Proposal for amendment to global technical regulation No.13 (Hydrogen and fuel cell vehicles)

Note: The modifications to ECE/TRANS/180/Add/13 are marked in bold and strikethrough characters.

“Figure 12 Example of the test method using D.C. power supply, voltmeter and ammeter

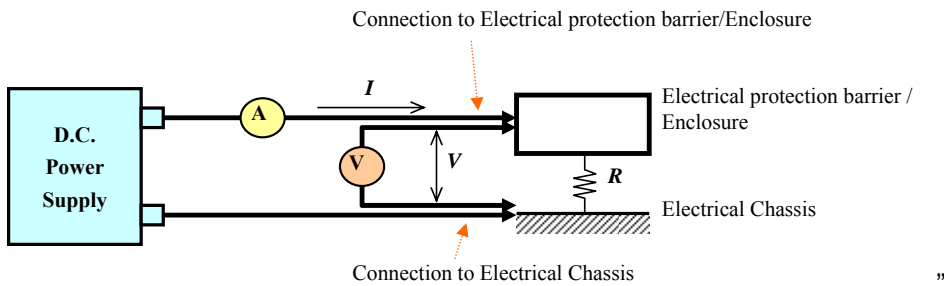
Figure 12, amend the title and replace the figure with:
